April 15, 2010

The enclosed documents are in response to the deficiencies and requests for clarification of Essential Isotopes application for NRC license control number 318475 and 318478. I hope that you find the responses satisfactory, if not please call me for further clarification

Essential Isotopes – Cyclotron Deficiencies Control # 318478

6. Figure 1.

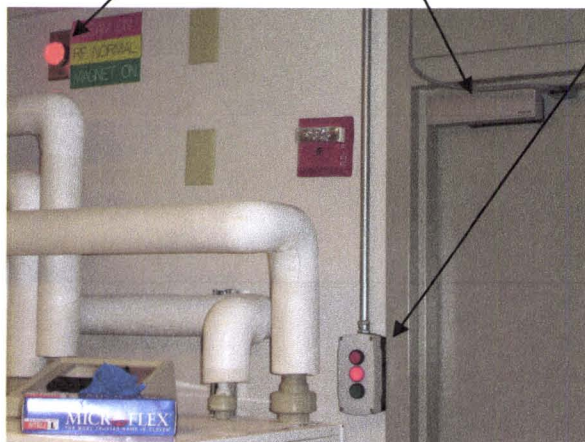
- 6. Describe the use of alarming system that is employed in the cyclotron room that would be activated in the event of entry into the cyclotron room while the unit is in operation. Describe the interlock system and how with works.**

2. The vault door is magnetically locked. (figure 1) This lock can only be disengaged when the systems powering the cyclotron are turned off. There is an indicator light in the electronics room that indicates the cyclotron status. (figure 1) The light designations are as follows:

3. The vault door is interlocked with the cyclotron power systems. If the interlock is not properly set the cyclotron will not power up. If the interlock is broken during irradiation power is immediately cut to all systems resulting in complete cyclotron shut-down.

4. There are two interlocks in the vault itself. These must be manually armed before leaving the vault before the final interlock can be engaged. The final interlock is outside the vault door (figure 1.) and must be engaged before the cyclotron can be powered up.

5. The Master Control System (MCS) monitors the vault door at all times. If the vault door is not secured an alarm will sound and a message will appear that identifies the interlock failure. There is no override from the MCS making it necessary for personnel to leave the production area to investigate and resolve the interlock failure.
